# TOWN OF UNDERHILL

## Development Review Board

KARLA & WILLIAM RUSSELL  
CONDITIONAL USE REVIEW  
Docket #: DRB-19-03

Applicant(s):	Karla & William Russell
Consultant/Representative:	Justin Willis & Briana Cornin
Property Location:	270 Pleasant Valley Road (PV270)
Acreage:	± 14.98 Acres
Zoning District(s):	Mt. Mansfield Scenic Preservation
Project Proposal:	Review of a Conditional Use Review application submitted by Karla & William Russell to building a pool and pavilion on steep slopes.

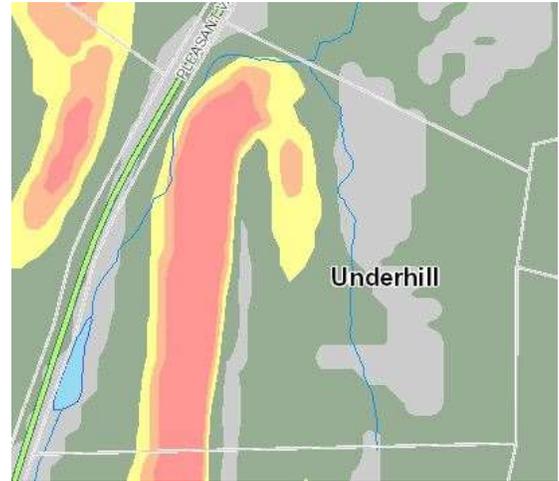
- While the ANR Atlas Map (see directly to the right) illustrates areas under 15% slope, when reviewing the submitted site plan (see Exhibit J), areas less than 15%, at least in close proximity to the single-family residence, have not been identified. Therefore, the above exemption seems plausible, as the Applicants have communicated to Staff that the lot was largely slopes prior to creating a leveled area for the existing single-family dwelling.
